Correspondence Between Staff and Applicant

RE: 8-DR-2019  
Spectrum - Camelback  
7N464 (Key Code)

The Planning & Development Services Division has completed the review of the above referenced development application submitted on 2/19/2019. The following **1<sup>st</sup> Review Comments** represent the review performed by our team, and is intended to provide you with guidance for compliance with city codes, policies, and guidelines related to this application.

Figure 6-11 Cross Section Locations at a Bridge or Culvert

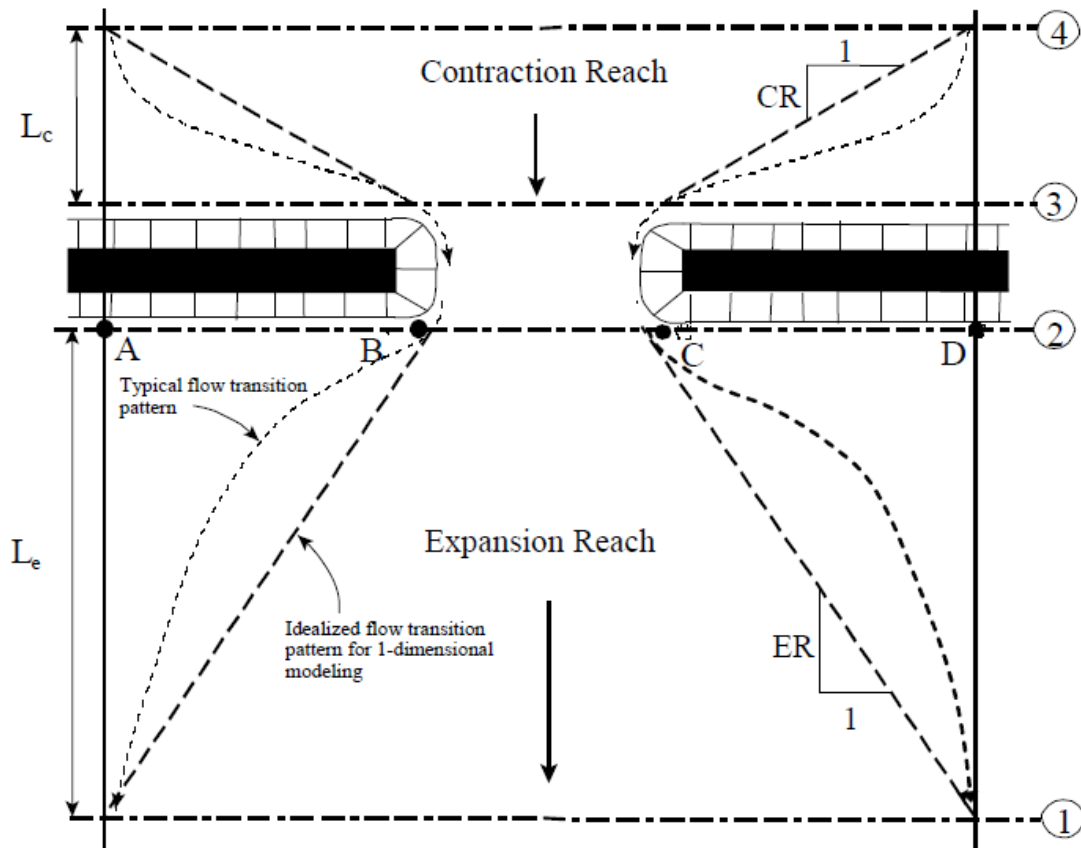
15. Is the HEC-RAS based on surveyed 1.0-foot contours or it based on the COS digital quarter section topographic maps? Please clarify it in the HEC-RAS section of the report. While it is ok not to model the 2-30" pipes under Camelback Rd in the HEC-RAS model, but the 3-barrel box culvert under Camelback Rd must be included in the HEC-RAS model to evaluate any backwater effect. The 3-barrel box culvert under Camelback Rd must be modeled in HEC-RAS by using the methodologies as outlined in the HEC-RAS User's Manual as shown below. Appropriate flow expansion and flow contraction coefficients must be used in the affected HEC-RAS cross-sections. Also, "ineffective flow areas" must be modeled in the HEC-RAS model as appropriate. [Reference: COS DS&PM: Section 4]

16. In the event the original HEC-2 model did not include the 3-barrel box culvert under Camelback Rd, this time it must be included. Also, the Manning's "n" values for the LOB, Main Channel, and the ROB seem very low (0.02, 0.025, etc.). Even if the original HEC-2 model may have used those Manning's "n" values, but such values can no longer be used in the current HEC-RAS model. The entire wash along with the floodplain area appears to be grass-lined and therefore, a single Manning's "n" value of 0.045 appears to be more representative for the LOB, Main Channel, and the ROB. Please reevaluate and modify the HEC-RAS model. [Reference: COS DS&PM: Section 4]

Figure 6-11 Cross Section Locations at a Bridge or Culvert

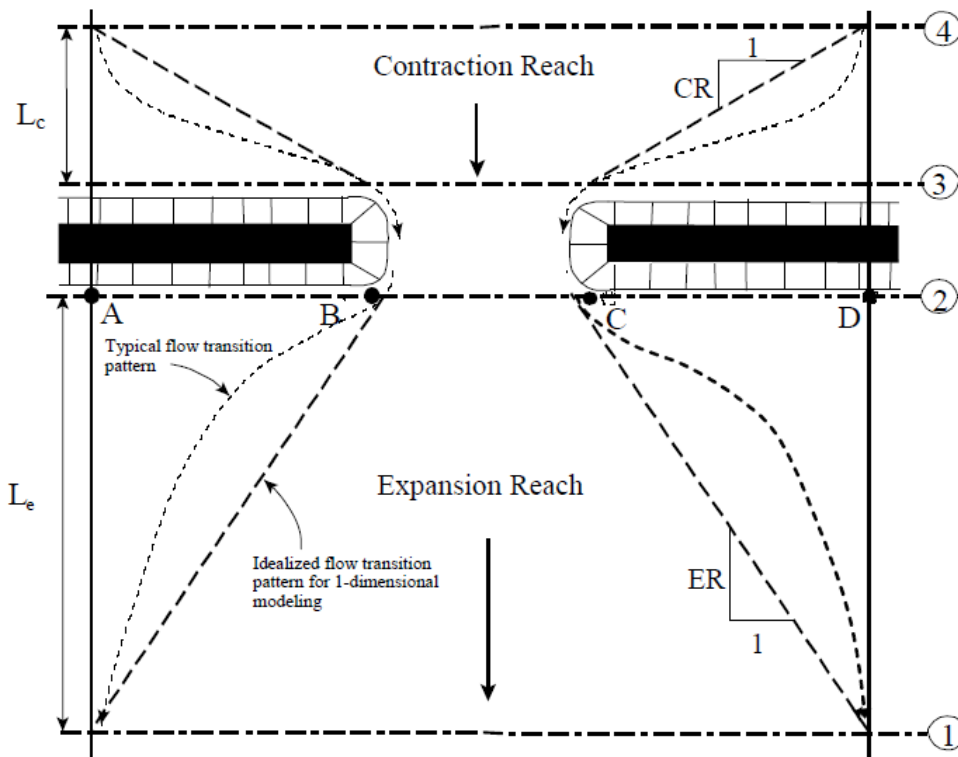
5. Is the HEC-RAS based on surveyed 1.0-foot contours or it based on the COS digital quarter section topographic maps? Please clarify it in the HEC-RAS section of the report. While it is understandable to not to model the 2-30" pipes under Camelback Rd in the HEC-RAS model, but modeling the 3-barrel existing box culvert under Camelback Rd in fact helps the Engineer with the RFE requirements. However, at the Engineer's discretion, he may only model Camelback Rd in HEC-RAS as a weir while disregarding the box culvert. In the event, the Engineer models the 3-barrel box culvert under Camelback Rd in HEC-RAS, then he must follow the methodologies as outlined in the HEC-RAS User's Manual as shown below. Appropriate flow expansion and flow contraction coefficients must be used in the affected HEC-RAS cross-sections. Also, "ineffective flow areas" must be modeled in the HEC-RAS model as appropriate. [Reference: COS DS&PM: Section 4]

6. The Manning's "n" values for the LOB, Main Channel, and the ROB seem very low (0.02, 0.025, etc.). Even if the original HEC-2 model may have used those Manning's "n" values, but such values can no longer be used in the current HEC-RAS model. The entire wash along with the floodplain area appears to be grass-lined and therefore, a single Manning's "n" value of 0.045 appears to be more representative for the LOB, Main Channel, and the ROB. Please reevaluate and modify the HEC-RAS model. [Reference: COS DS&PM: Section 4]

Figure 6-11 Cross Section Locations at a Bridge or Culvert

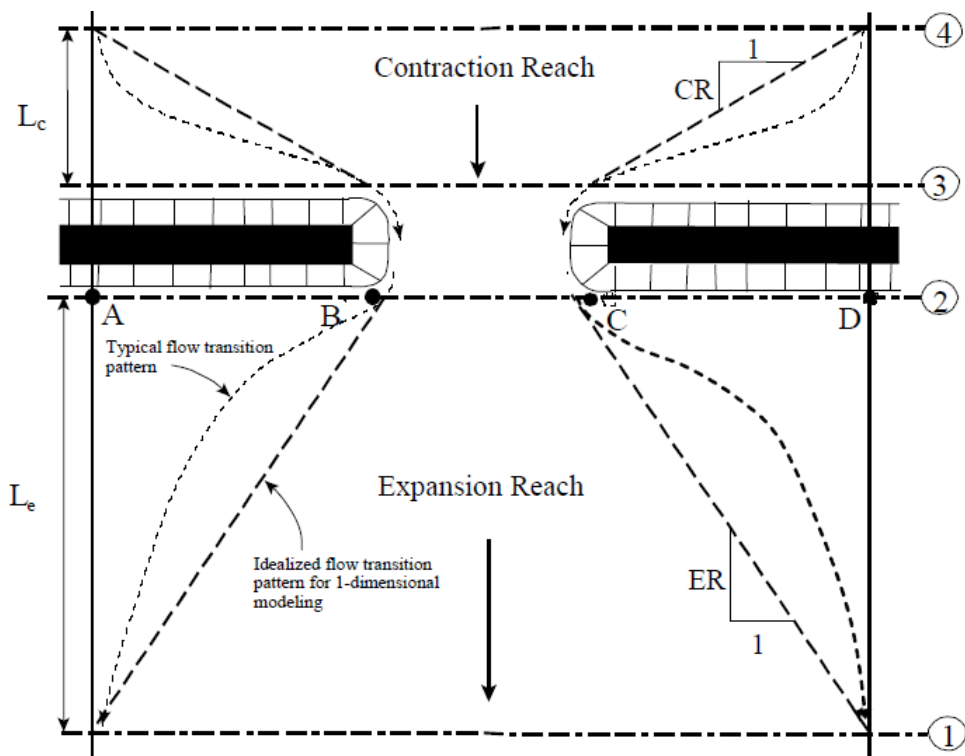
5. Is the HEC-RAS based on surveyed 1.0-foot contours or it based on the COS digital quarter section topographic maps? Please clarify it in the HEC-RAS section of the report. While it is understandable to not to model the 2-30" pipes under Camelback Rd in the HEC-RAS model, but modeling the 3-barrel existing box culvert under Camelback Rd in fact helps the Engineer with the RFE requirements. However, at the Engineer's discretion, he may only model Camelback Rd in HEC-RAS as a weir while disregarding the box culvert. In the event, the Engineer models the 3-barrel box culvert under Camelback Rd in HEC-RAS, then he must follow the methodologies as outlined in the HEC-RAS User's Manual as shown below. Appropriate flow expansion and flow contraction coefficients must be used in the affected HEC-RAS cross- sections. Also, "ineffective flow areas" must be modeled in the HEC-RAS model as appropriate. [Reference: COS DS&PM: Section 4]

6. The Manning's "n" values for the LOB, Main Channel, and the ROB seem very low (0.02, 0.025, etc.). Even if the original HEC-2 model may have used those Manning's "n" values, but such values can no longer be used in the current HEC-RAS model. The entire wash along with the floodplain area appears to be grass-lined and therefore, a single Manning's "n" value of 0.045 appears to be more representative for the LOB, Main Channel, and the ROB. Please reevaluate and modify the HEC-RAS model. [Reference: COS DS&PM: Section 4]

**Response:** the culvert is part of Indian bend wash low flow channel on the west side of Hayden Road and it is not part of this model. Camelback Road was modeled with two cross sections (weir) in the effective model (cross sections 5.372 and cross sections 5.360), those two cross sections remains in the Indian Bend Wash model.
